REVISED RESPONSE TO REQUEST FOR ADDITIONAL INFORMATION

APR1400 Design Certification

Docket No. 52-046

RAI No.:270-7894SRP Section:SRP 19Application Section:19.1.Date of RAI Issue:10/22/2015

Attachment 1 – Section 19.1.9 DCD Markup for Question PRA-130

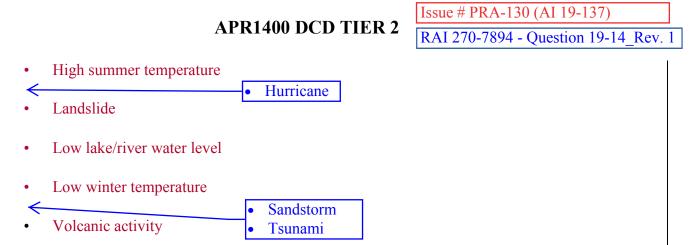
COL 19.1(8) The COL applicant is to address the following issues with a site-specific risk assessment, as applicable:

Dam failure Aircraft crash event
External flooding
• Extreme winds and tornadoes
 Industrial or military facility Lightning
Pipeline accident
• Release of chemicals from onsite storage
• River diversion < /River flooding
• Sandstorm
Toxic gas
